Application no: 24/01209/DISC

Location: Heyford Park, Camp Road, Upper Heyford, OX25 5HD

Transport Development Management

The application seeks approval to discharge condition 6 pursuant to planning consent no. 18/00825/HYBRID, which requires the submission of a Design Code for the site.

Parcel 11

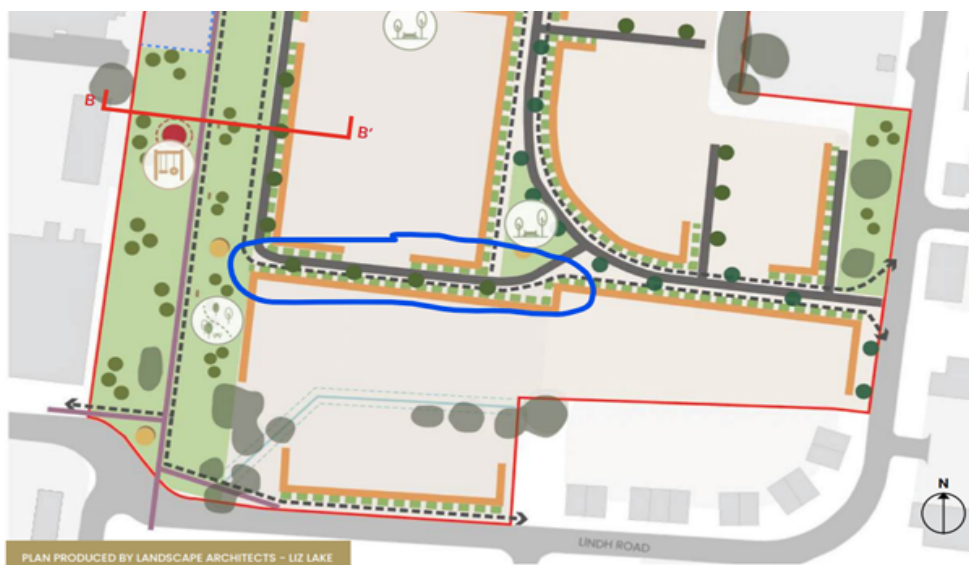
Am interested to understand the relationship between pedestrian/ cyclist provisions alongside the carriageway around the section between building (circled in blue below). My concern is that only one frontage of the building line appears to have a pedestrian/ cyclist facility whilst the other does not. While the details of the buildings shall progress through reserved matters, any frontage that opens up to a road should have a walking facility.
